Memorandum to the City of Markham Committee of Adjustment

File: A/111/21
Address: 683 Village Parkway – Markham, ON
Applicant: Changchun Mu
Agent: Cube Architects Inc. (Shaowei Cheng)
Hearing Date: September 8, 2021

TO PROPOSE AN ADDITION OVER GARAGE AND FAMILY ROOM AND INTERIOR ALTERATION AT 683 VILLAGE PARKWAY

1 SITE PLAN
 A0.1 1/8" = 1'-0"

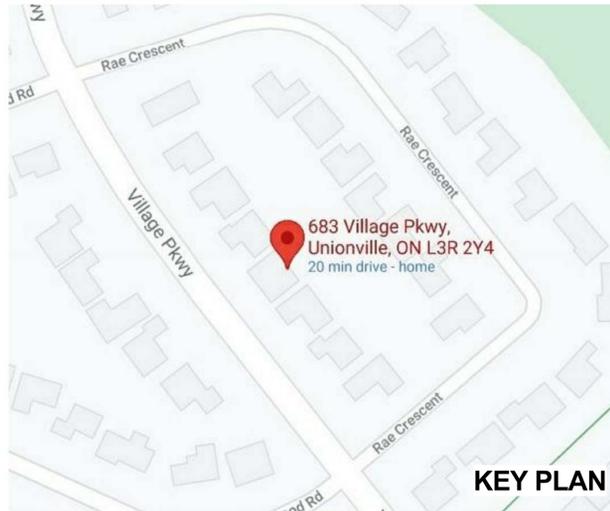
The applicant is requesting a minimum front yard setback of 6.24 m (20.47 ft), whereas the By-law requires a minimum front yard setback of 8.23 m (27.0 ft). This is a reduction of 1.99 m (6.53 ft). The By-law allows attached garages to have a front yard setback of 6.10 m (20.0 ft), and staff note the requested variance would therefore apply to the:

- proposed second-storey addition;
- existing covered front porch; and
- proposed extension to the existing covered porch.

The second-storey addition would align with the existing north and west building walls at the first-storey. While the second-storey addition will add some mass to the front of the dwelling, staff are of the opinion that the proposed addition would be of minimal impact, while allowing the applicant to expand their living space and make for appropriate use of the existing footprint. If approved, the existing covered front porch and proposed extension thereof would align with the south and west building walls. As the existing covered front porch is unenclosed, staff are satisfied that its existing location, and the proposed extension thereof, will not significantly contribute to the overall mass of the building.

The applicant is also requesting a minimum north side yard setback of 1.26 m (4.13 ft), whereas the By-law requires a minimum side yard setback of 1.83 m (6.0 ft) for the two-storey portion of the dwelling. This is a reduction of 0.57 m (1.87 ft).

The existing garage and dwelling complies with the side yard setback requirement of 1.20 m (4.0 ft) for the first-storey. The requested variance is required to permit a setback of

1.26 m (4.13 ft) for the second-storey addition along the north side. The intent of having separate side yard setback requirements for first and second-storey portions of a building is to provide for:

The second-storey addition would be within the footprint of the existing dwelling, and Engineering staff have not identified any concerns relating to drainage. Urban Design staff have also reviewed the application, and in giving consideration to the applicant's request, staff are of the opinion that the reduction would result in minimal shadowing impacts to the neighbouring property to the north.
